Overland[®] MotorCoach

November 24, 1999

Overland has determined that a defect which relates to motor vehicle safety exists in all models of Lorados manufactured between July 10, 1997 and November 17, 1999. These vehicles have 3" electrical conduit routed through the engine area with no heat shield protection. If this conduit gets hot, it can melt, burn or catch fire causing damage to motor home and (or) persons.

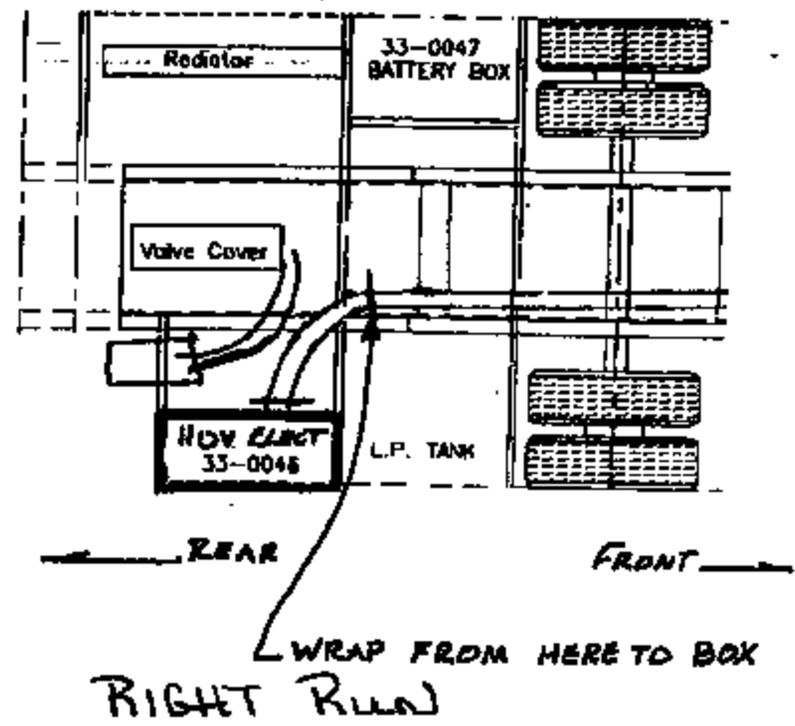
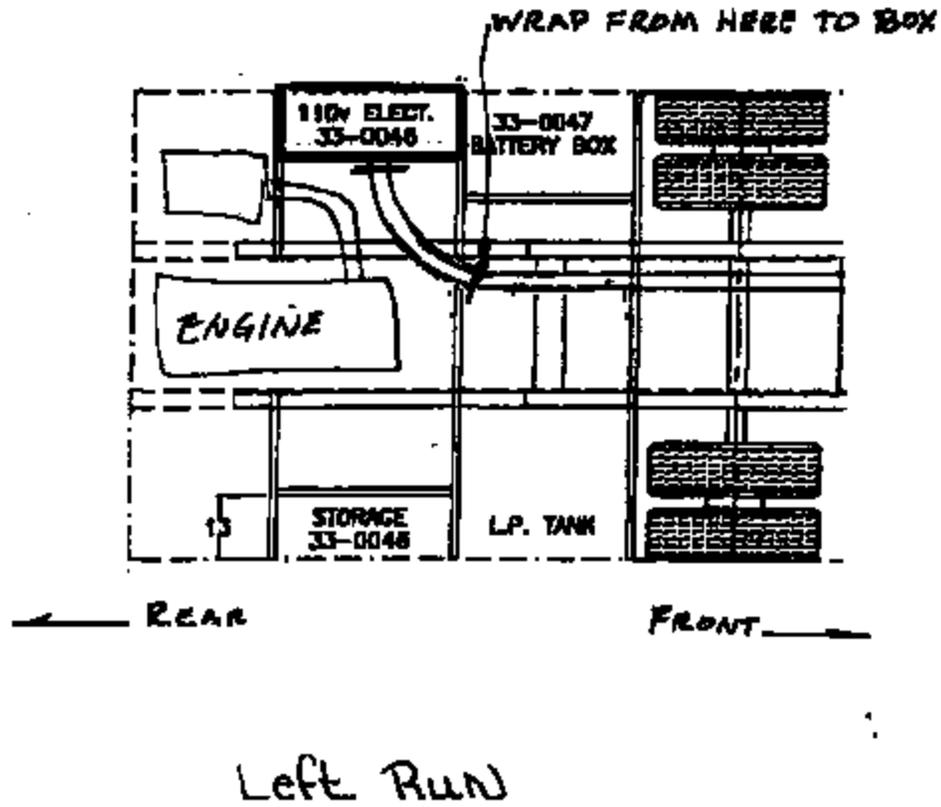
THESE UNITS ARE ALL DIESEL PUSHERS. THE CONDUIT RUNNING OVER MOTOR AREA WILL DIPPER FROM ONLY 4" EXPOSED AND UP TO 12" DEPENDING ON WHICH MODEL. IT IS EASILY IDENTIFIABLE. IT IS THE ONLY 3" PLASTIC ELECTRIC CONDUIT IN REAR. RUNS DIRECTLY TO BACK OF 110v PANEL BOX.

THESE UNITS ARE ALL DIESEL PUSHERS. THE CONDUIT RUNNING OVER MOTOR AREA WILL DIFFER FROM ONLY 4" EXPOSED AND UP TO 12" DEPENDING ON WHICH MODEL. IT IS EASILY IDENTIFIABLE, IT IS THE ONLY 3" PLASTIC ELECTRIC CONDUIT IN REAR. RUNS DIRECTLY TO BACK OF 110V PANEL BOX.

This is a situation that takes very little time to correct. We have made up a kit consisting of flexible heat deflector, two clamps to install the deflector and a clamp to fasten the pipe up with. This will be done at no charge to you the consumer.
